GIBB, UNDERWOOD & McLELLAN CONSULTING ENGINEERS		C.U.M. DWG. No. 108-1	
DEPARTMENT OF HIGHWAYS, ONTARIO BRIDGE OFFICE - TORONTO			
CONESTOGO RIVER BRIDGE AT ARTHUR			
THE KING'S HIGHWAY No. 6		DIST. No. 5	
CO. WELLINGTON		LOT	
TWP. ARTHUR		CON.	
APPROVED			
BRIDGE ENGINEER		DESIGN ENGINEER	
DATE MARCH 1962		H 20-S16	
DRAWING NUMBER		DRAWING NUMBER	
D 4459 A		D 4459 A

Re: Conestoga River Bridge,
Arthur, Ont.
Hwy. #6 - Dist. #3 - W.P. 152-59.

The foundation report prepared by Hacey MacCallum and Associates in connection with the above site, and accompanying this memo, has been reviewed by the Foundation Section. Our review of this report has led to the following conclusions:-

RE: FOUNDATION INVESTIGATION FOR
BRIDGE W.P. 152-59, HIGHWAY #6, DISTRICT #3
VILLAGE OF ARTHUR, ONTARIO

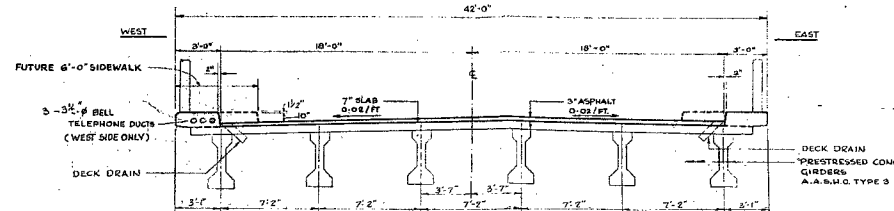
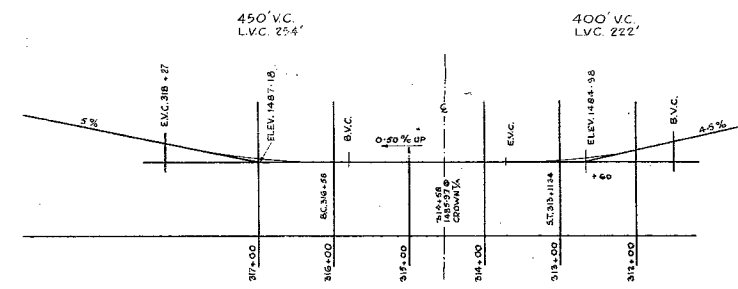
Drawing reviewed; footings in compliance with foundation report recommendations. No comments after March 13, 1962.
